Rezoning Application: PD 25-1061
Zoning Hearing Master Date: April 27, 2026
BOCC Hearing Meeting Date: June 9, 2026

APPLICATION NUMBER: PD 25-1061

AGENCY REVIEW COMMENT SHEET

Project Name/ Phase	Lovegren South RV Park
<p><i>Important: The name selected must be used on all future communications and submittals of additional/revised information relating to this variance. If request is specific to a discrete phase, please also list that phase.</i></p>	
Folio Number(s)	50679.0000, 50681.0000, 50681.6000
<input type="checkbox"/> Check This Box If There Are More Than Five Folio Numbers	
<p><i>Important: List all folios related to the project, up to a maximum of five. If there are additional folios, check the box to indicate such. Folio numbers must be provided in the format provided by the Hillsborough County Property Appraiser's website (i.e. 6 numbers, followed by a hyphen, followed by 4 additional numbers, e.g. "012345-6789"). Multiple records should be separated by a semicolon and a space e.g. "012345-6789; 054321-9876").</i></p>	
Name of Person Submitting Request	Steven J. Henry, P.E.

8.0 PROPOSED SITE PLAN (FULL)

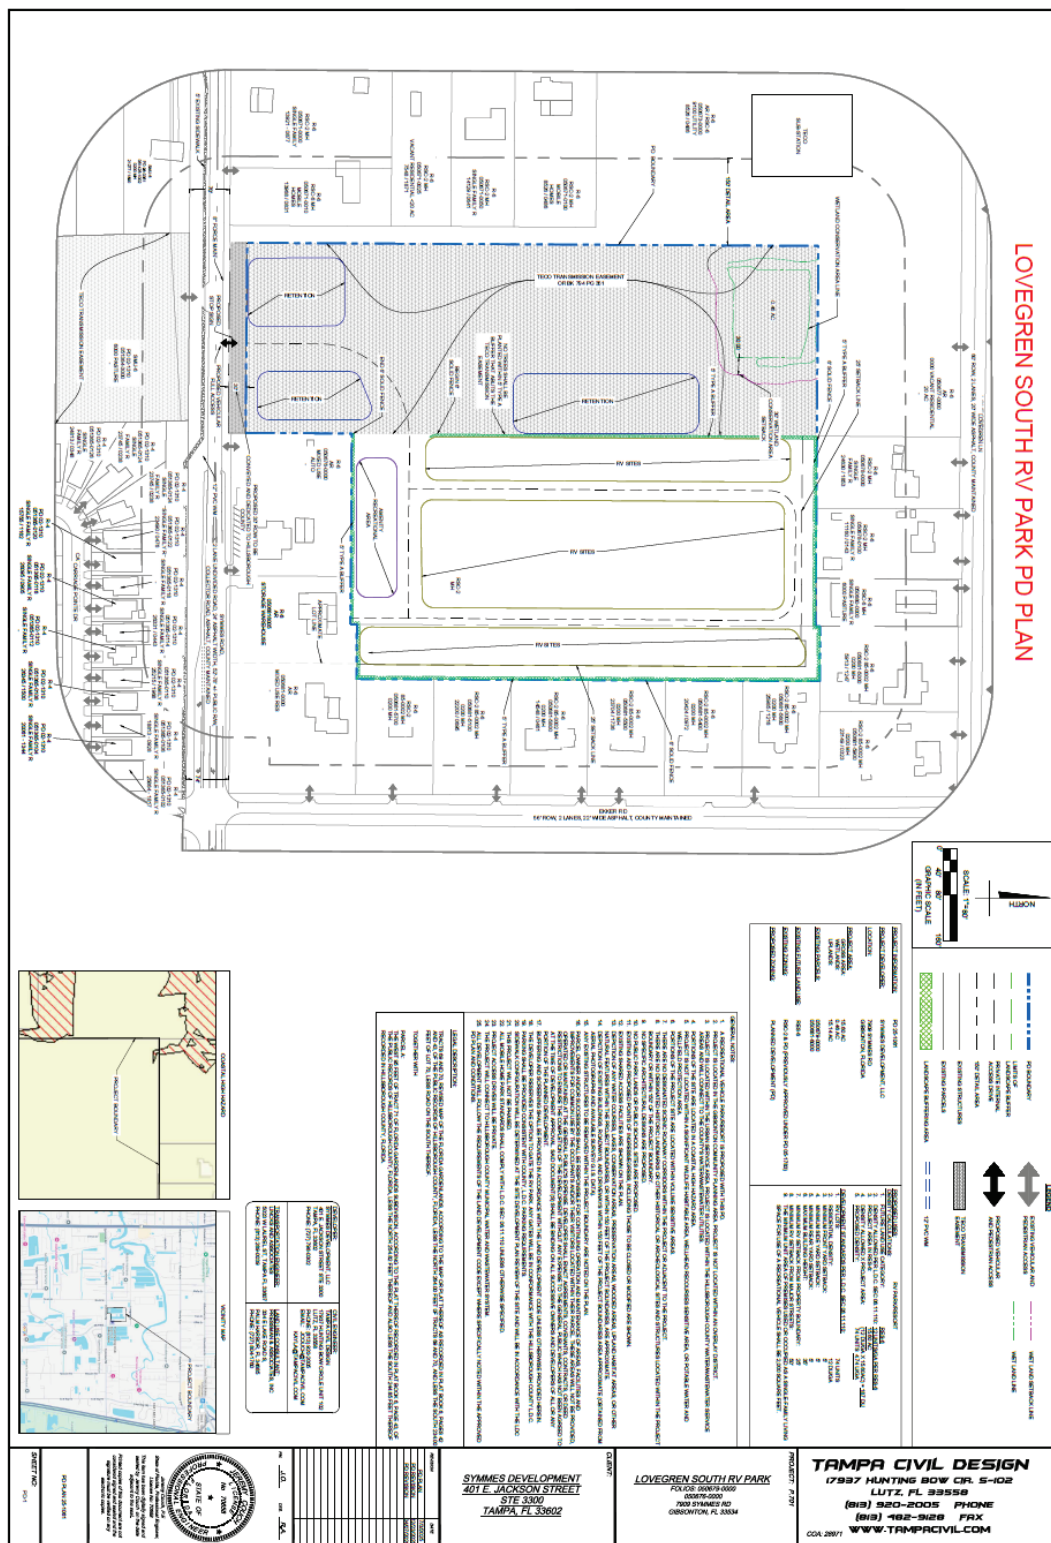
Prior to PD site plan certification, the developer shall revise the PD site plan to:

Approval of the request, subject to the conditions listed, is based on the revised general site plan submitted April 6, 2026.

Figure 1

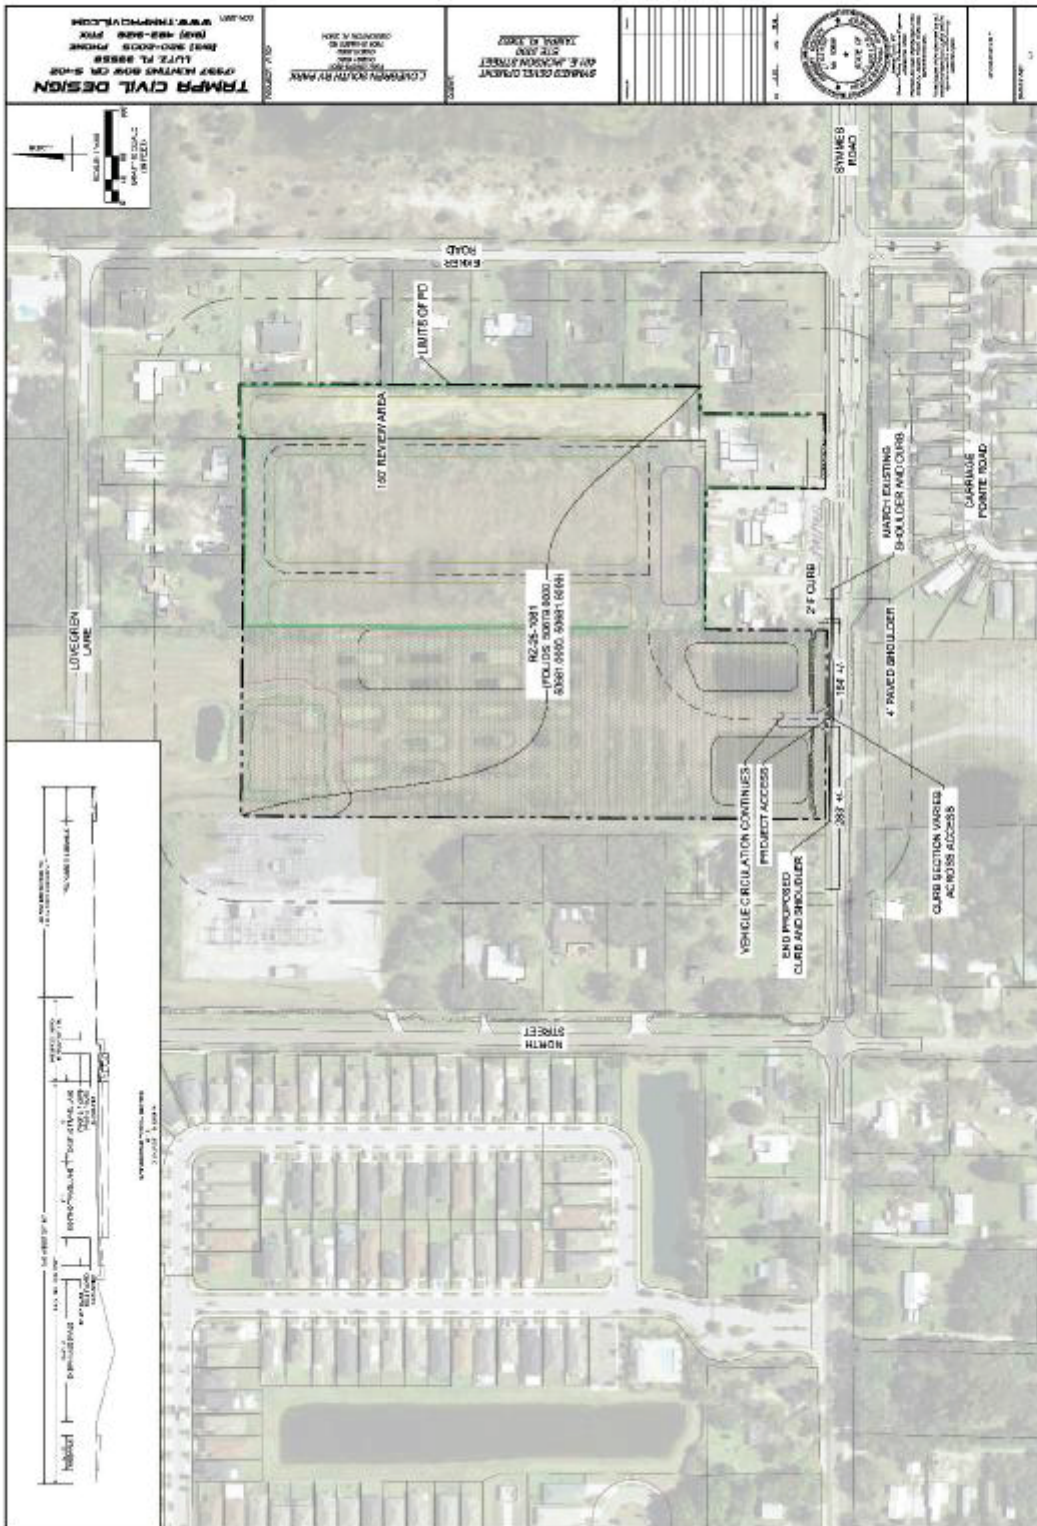
The request is for an Administrative Variance to Section 6.04.07 of the Hillsborough County LDC for the access spacing on Symmes Road. Based on Section 6.04.07, the access spacing on Symmes Road is 245 feet. The distance to the driveway to the west is 283 feet and 164 feet to the east. This is graphically shown in Figure 1.

Figure 1

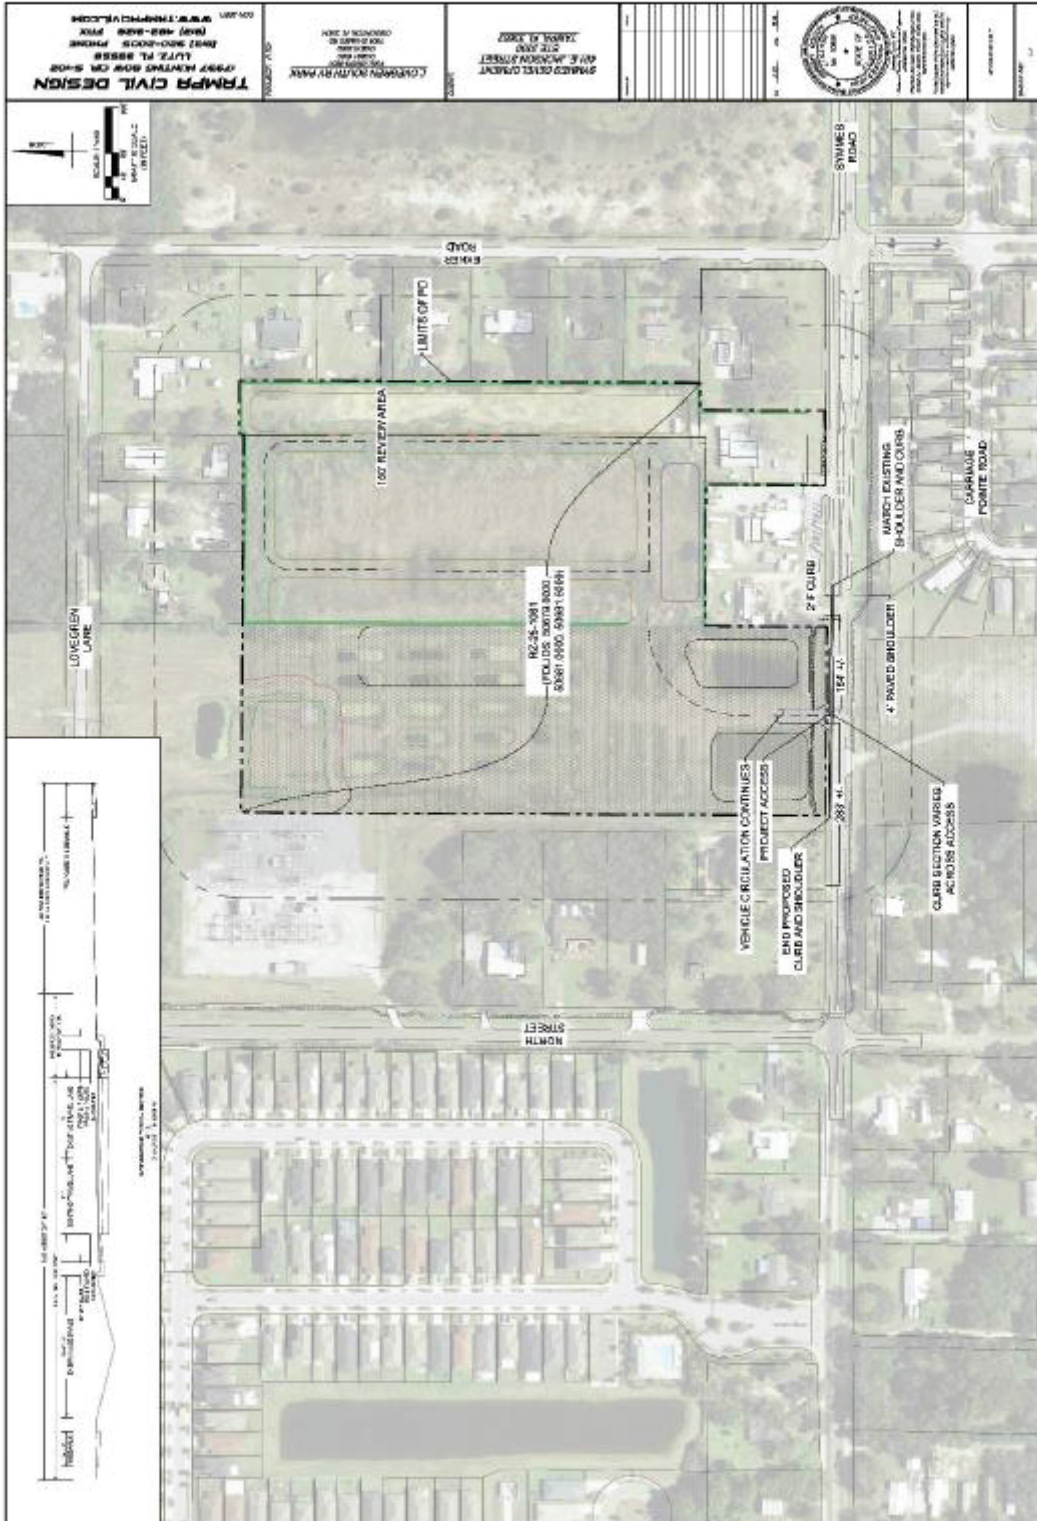
The proposed improvements and typical section are shown on Figure 1.

Figure 1

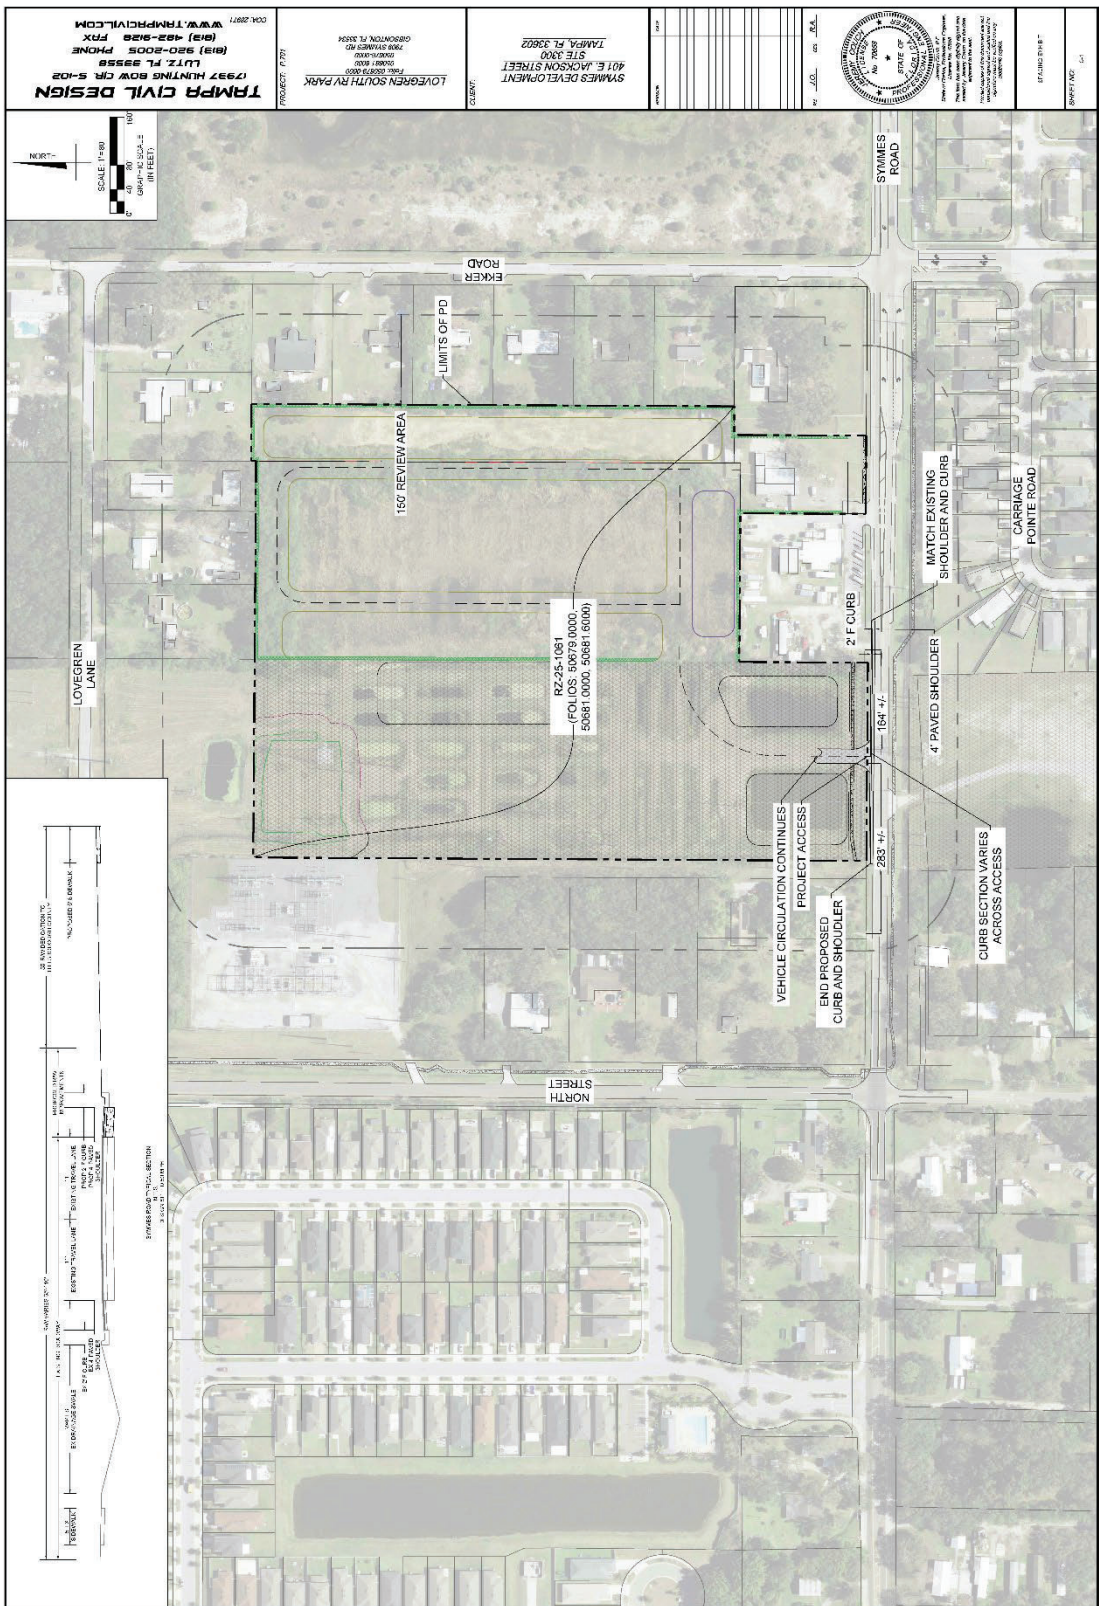
The request is for an Administrative Variance to Section 6.04.07 of the Hillsborough County LDC for the access spacing on Symmes Road. Based on Section 6.04.07, the access spacing on Symmes Road is 245 feet. The distance to the driveway to the west is 283 feet and 164 feet to the east. This is graphically shown in Figure 1.

Figure 1

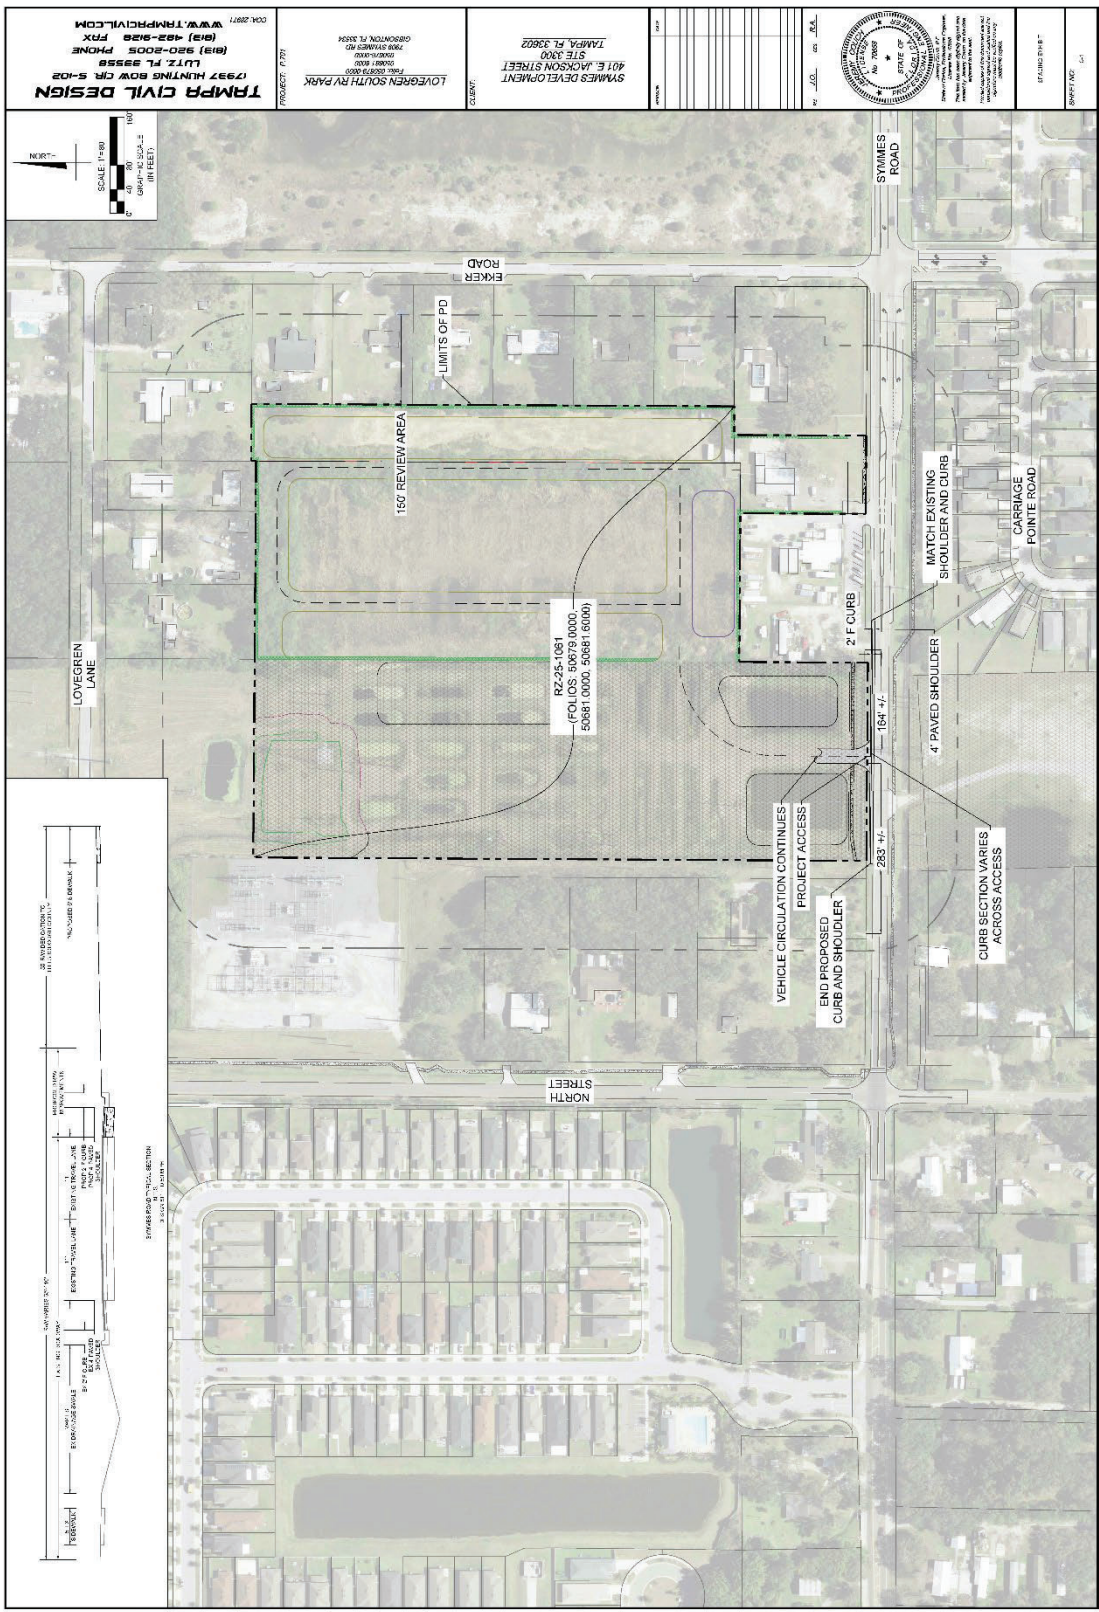
1. The Developer proposes to extend the curb and gutter from the existing terminus east of the project to the western property line.

The proposed improvements and typical section are shown on Figure 1.
